**BARWELL MEDICAL CENTRE
HIGH STREET, BARWELL,
LEICESTERSHIRE**

PROPOSED HIGHWAY ACCESS

ROAD SAFETY AUDIT REPORT

Document: Stage 2 Road Safety Audit

Appendix A

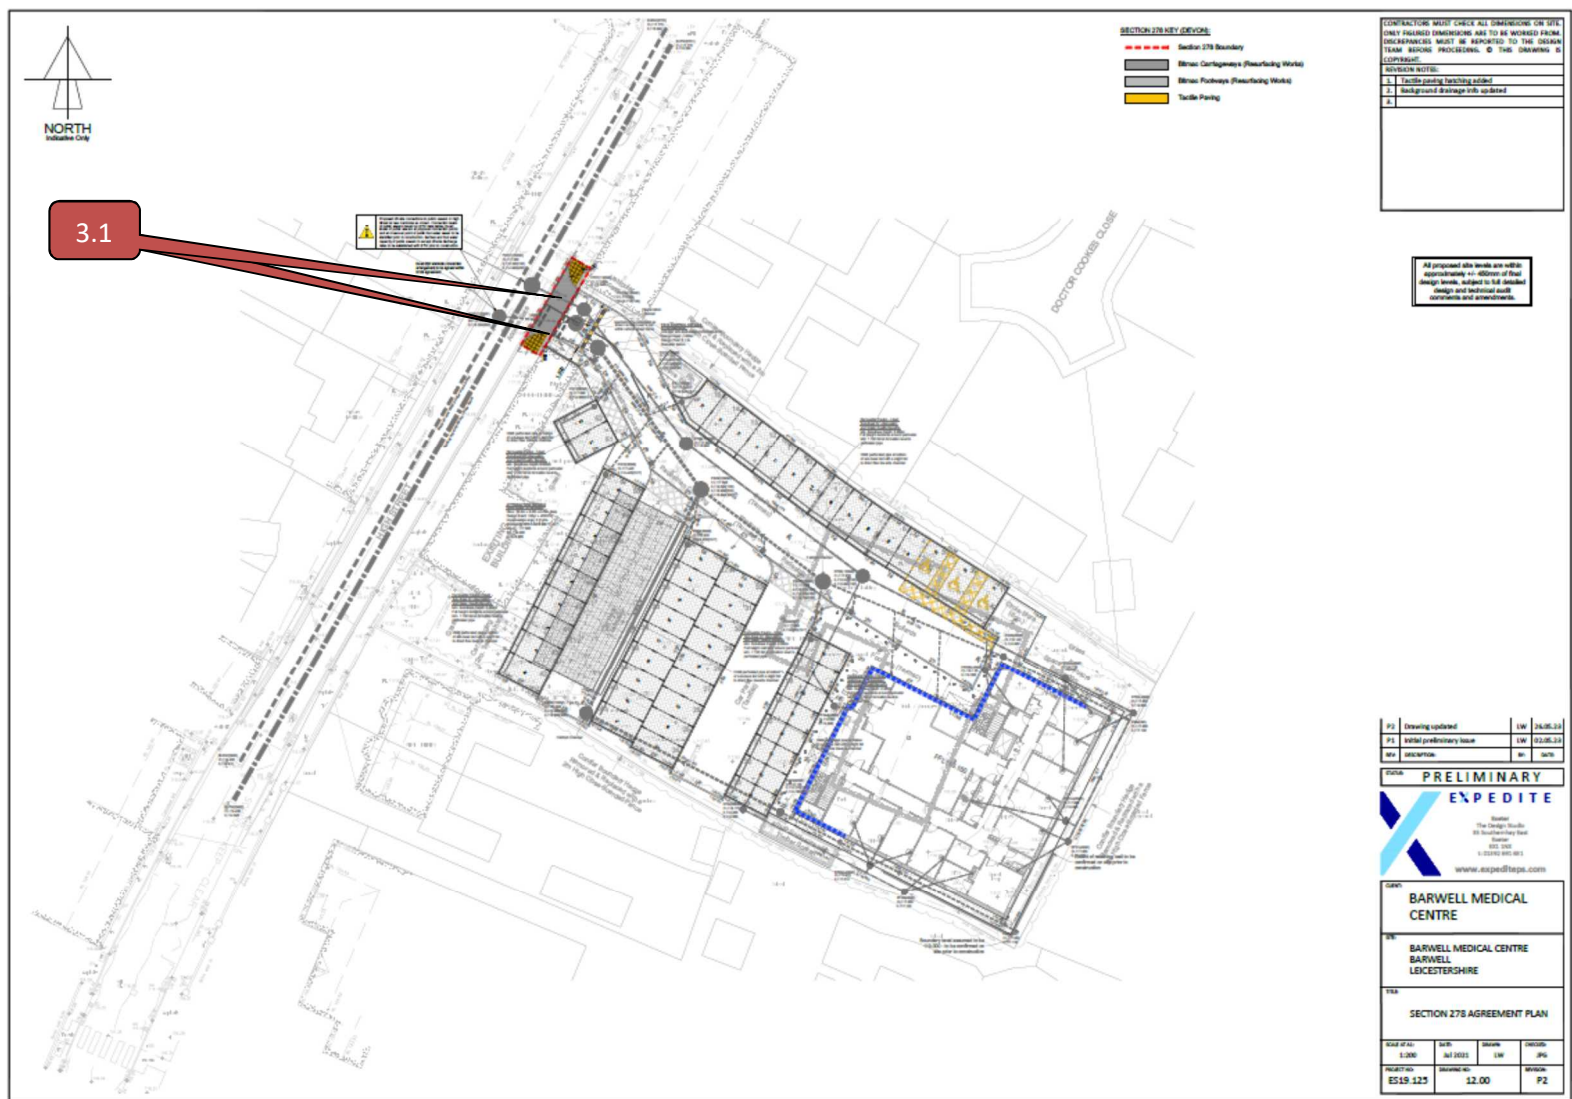
3.1 **Problem:**

Summary: Potential risk of collisions associated with ambiguous carriageway markings

Location: *Entry/egress to development*

The proposed carriageway markings on the entry/egress to the development access are ambiguous with two sets of give way and edge of carriageway markings proposed. The layout is confusing and may increase the risk of collisions between road users associated with inadvertent manoeuvres.

Review and amend the layout to provide a clear layout of the development access.

Item No.	Audit Team Recommendation(s)	Designer's Response
3.1	The proposed carriageway markings on the entry/egress to the development access are ambiguous with two sets of give way and edge of carriageway markings proposed. The layout is confusing and may increase the risk of collisions between road users associated with inadvertent manoeuvres.	Noted. Second set of give way and edge of carriageway markings within the site removed.
